V8 XJ Series

501-46

TECHNICAL BULLETIN

Memory Buttons Hot To Touch –
Component Serviceability –
Repair ProcedureMODEL 1998 MY-ON
V8 XJ Series

ILLUSTRATION 1

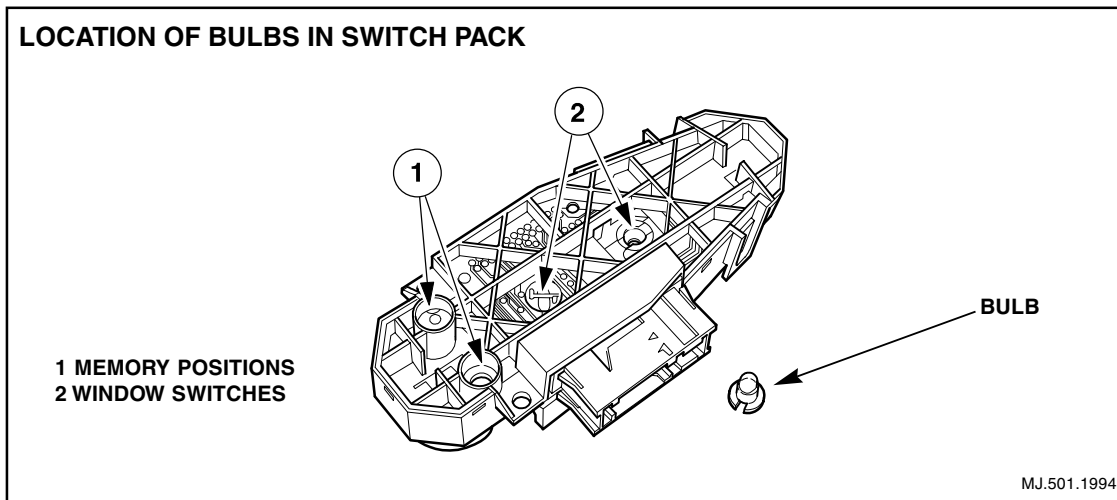
Note: The bulbs within the switch pack (Illustration 1) should only be replaced for the above complaint or if they are faulty or blown. Vehicles up to VIN F11700 were equipped with 100 ma bulbs for the seat memory control buttons, which then changed to 50 ma bulbs. Do not replace complete switch packs for such complaints, as this will result in the non-payment of the warranty claim.

2. Remove the door casing. (See workshop manual, JTIS CD ROM section 501-05, SRO 76.34.01).
3. Disconnect the switch pack connector.
4. Remove the armrest to expose the switch pack assembly. (See workshop manual, JTIS CD ROM section 501-11. SRO 86.46.12).
5. Using a screwdriver and a small pair of pointed tweezers, remove the bulb from the switch pack assembly (Illustration 1) (Refer to SRO 86.46.12). **Replace the memory position bulbs (item 1, Illustration 1) with 50 ma bulbs (blue base) only.**

ILLUSTRATION 2

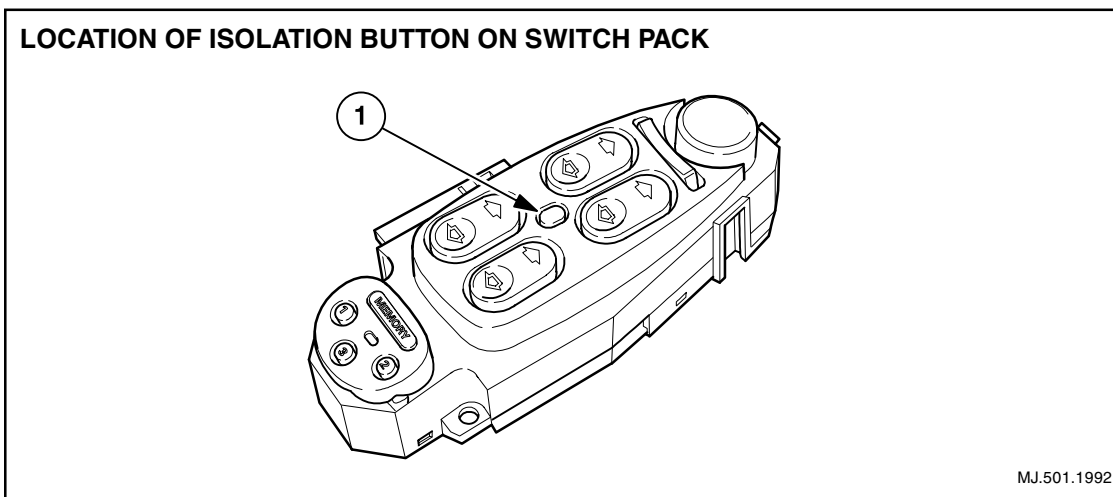
- Excessively hot memory buttons in the window switch pack – hot to touch.
- Missing window isolation button.

6. If missing or damaged, install a new isolation button into the switch pack ensuring it is fully depressed into the housing or until an audible click is heard. (See item 1, Illustration 2). Button can be removed with a small pair of tweezers/pliers.
